Office Action Summary	Application No. 10/605,663	Applicant(s) LANE, RONALD S.	
	Examiner Gwendolyn Baxter	Art Unit 3632

This is the third office action for application serial no. 10/605,663, Bookstand that Folds Thin Enough to serve as a Bookmark filed October 16, 2003.

ATTACHMENT

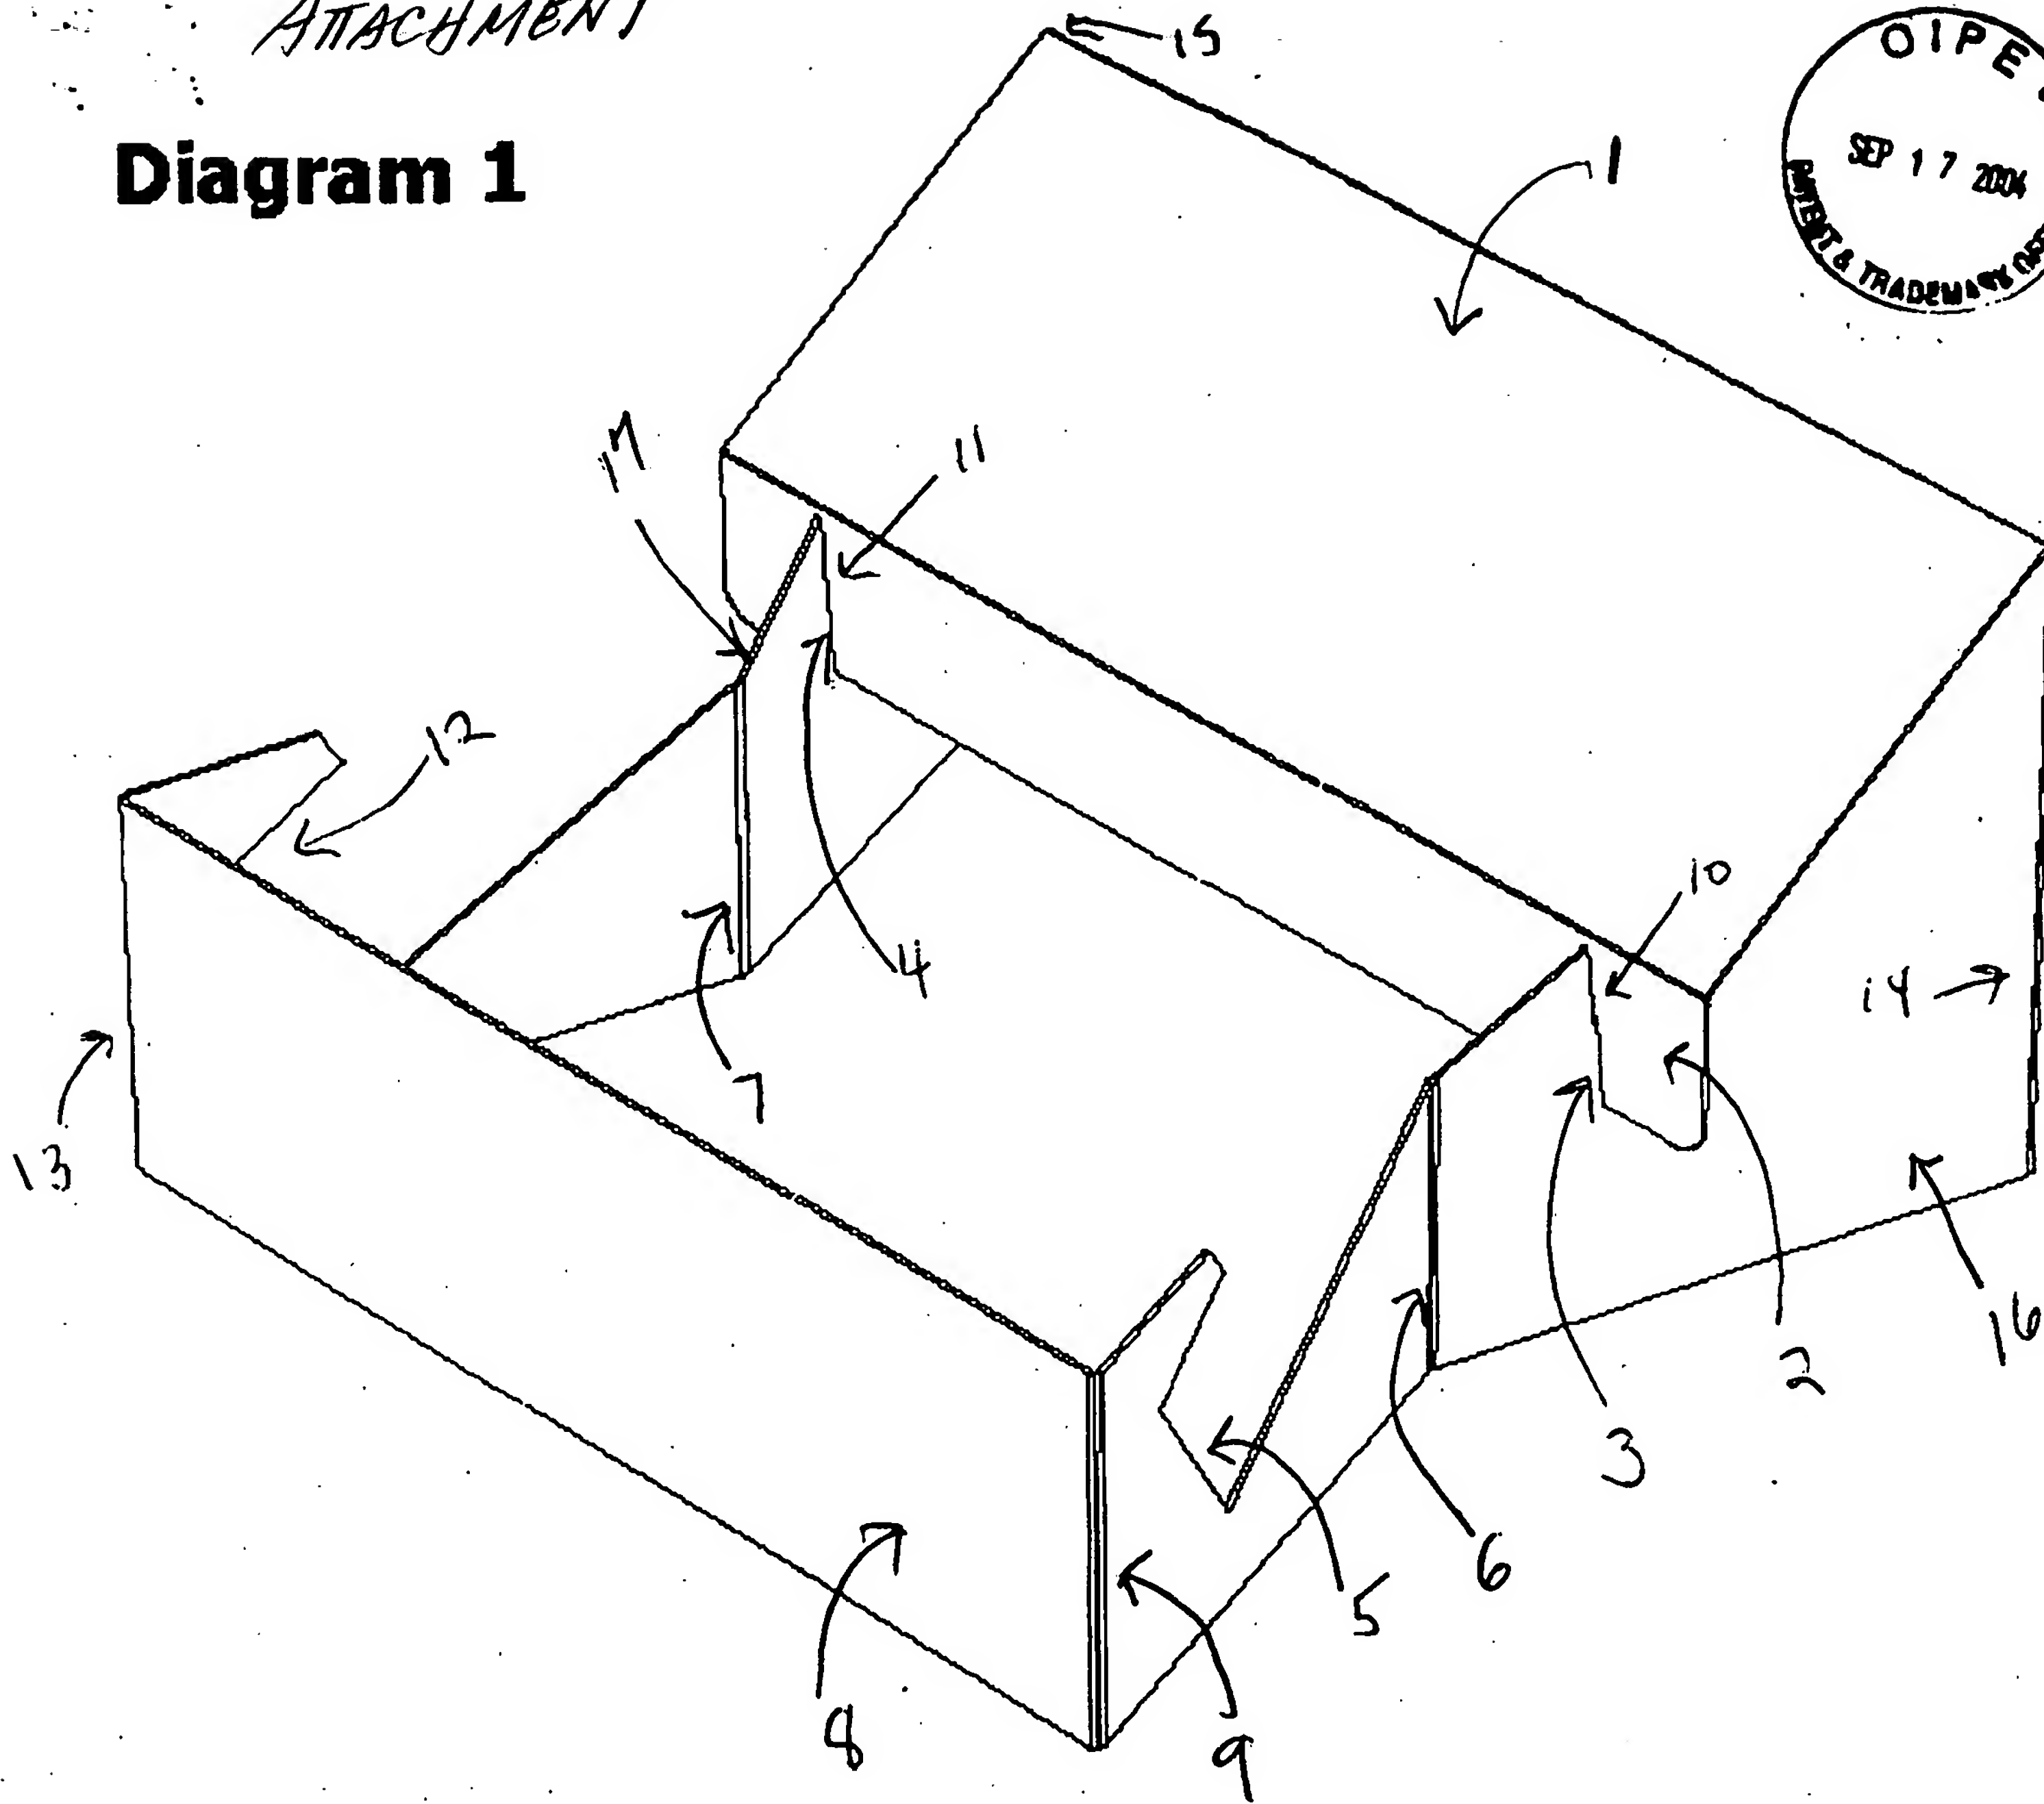
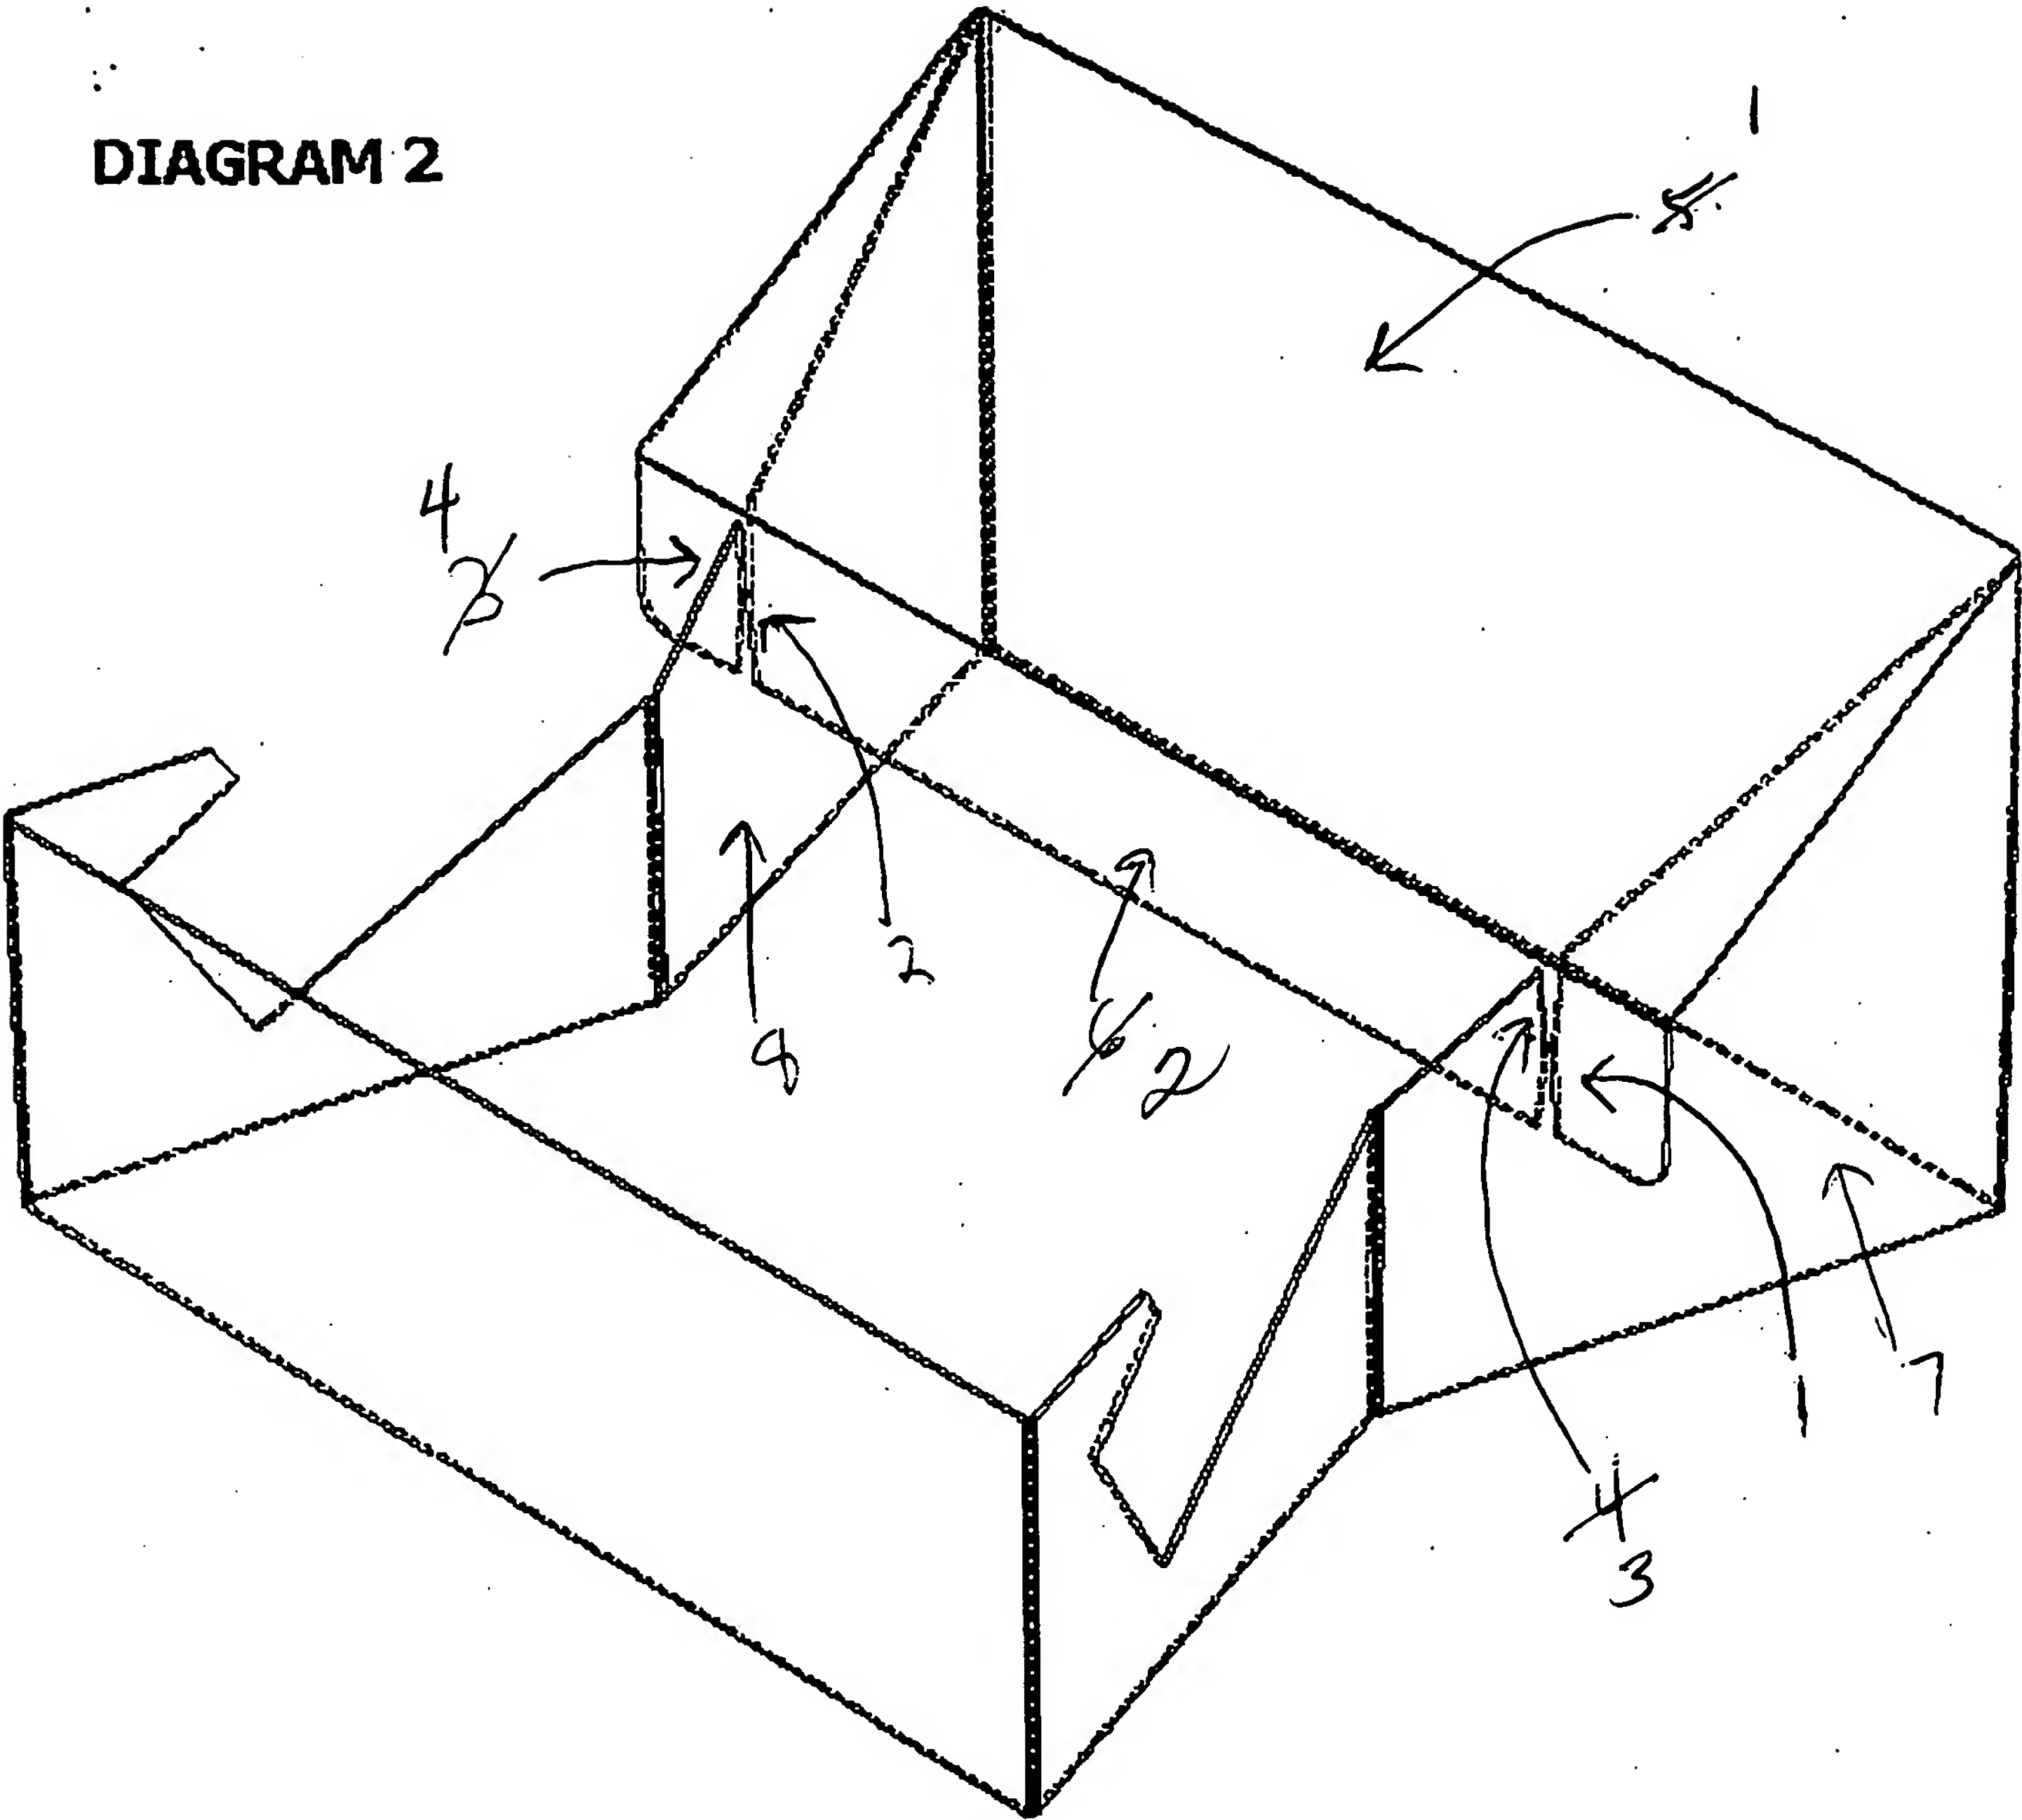
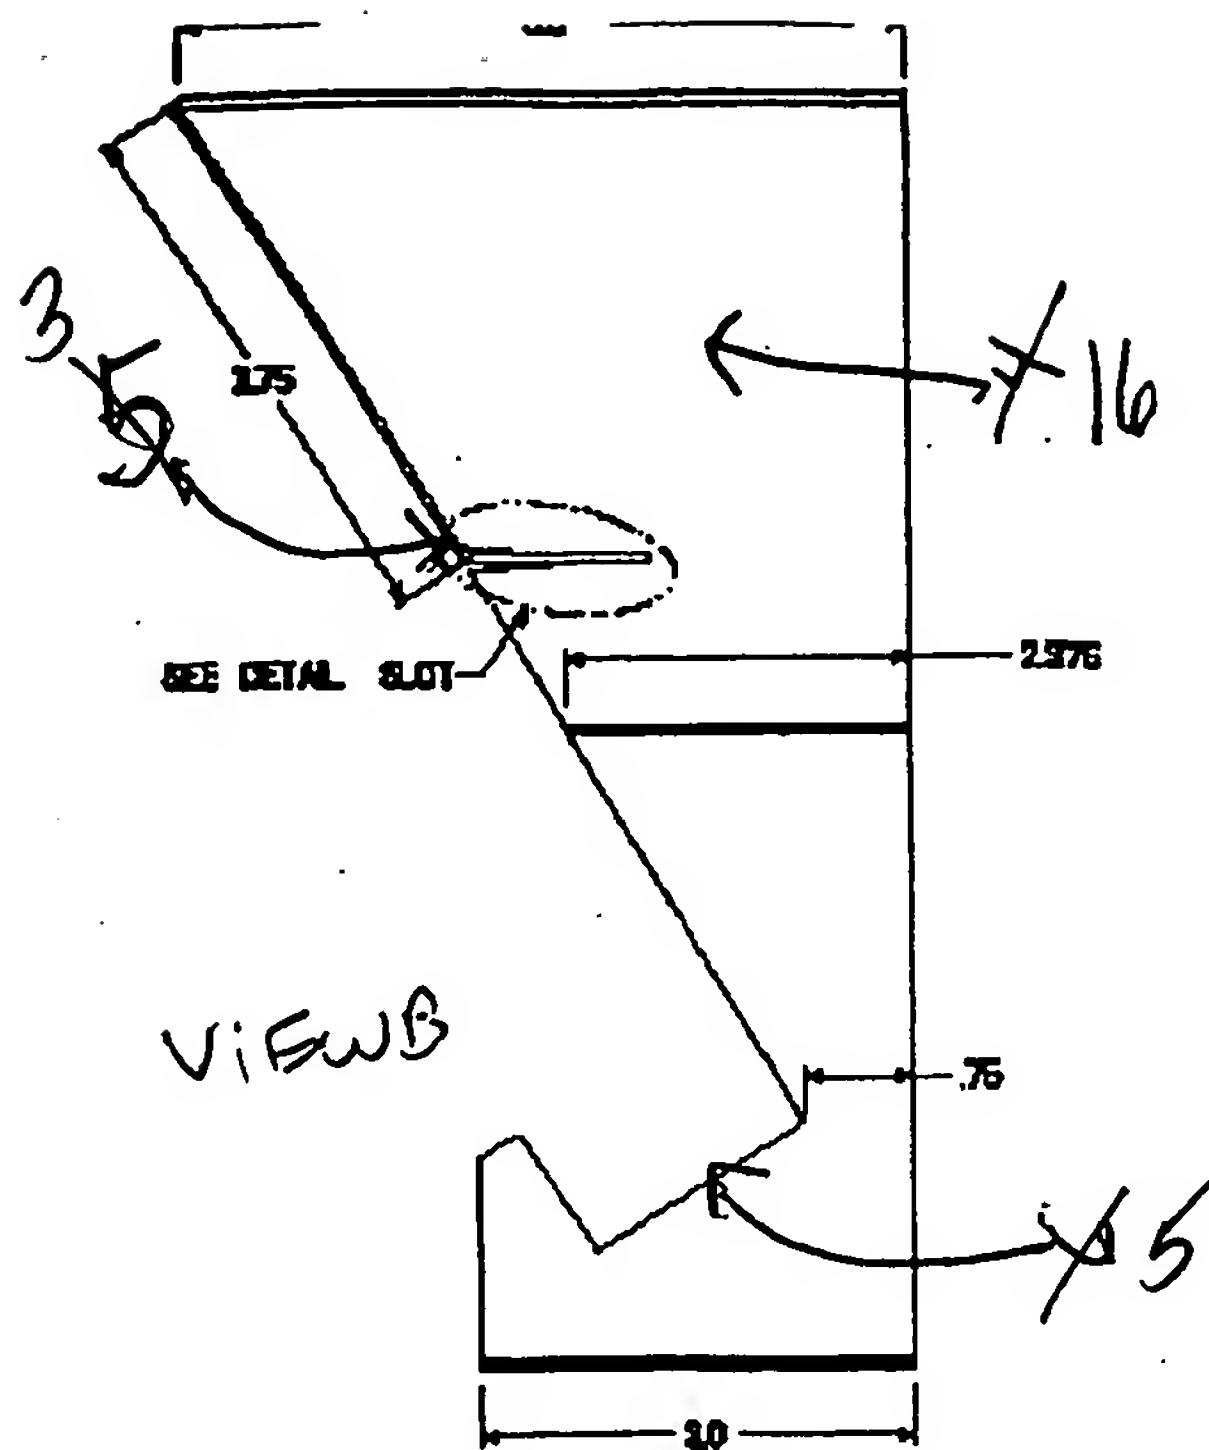
In order to reconcile the reference numerals in the specification and drawings, the following suggestions are made to correct different parts with the same reference numerals and/or different numbers for the same part. See modified copy of the drawing supplied by the examiner.

Corrected drawing sheets in compliance with 37 CFR 1.121(d) are required in reply to the Office action to avoid abandonment of the application. Any amended replacement drawing sheet should include all of the figures appearing on the immediate prior version of the sheet, even if only one figure is being amended. Each drawing sheet submitted after the filing date of an application must be labeled in the top margin as either "Replacement Sheet" or "New Sheet" pursuant to 37 CFR 1.121(d). If the changes are not accepted by the examiner, the applicant will be notified and informed of any required corrective action in the next Office action. The objection to the drawings will not be held in abeyance.
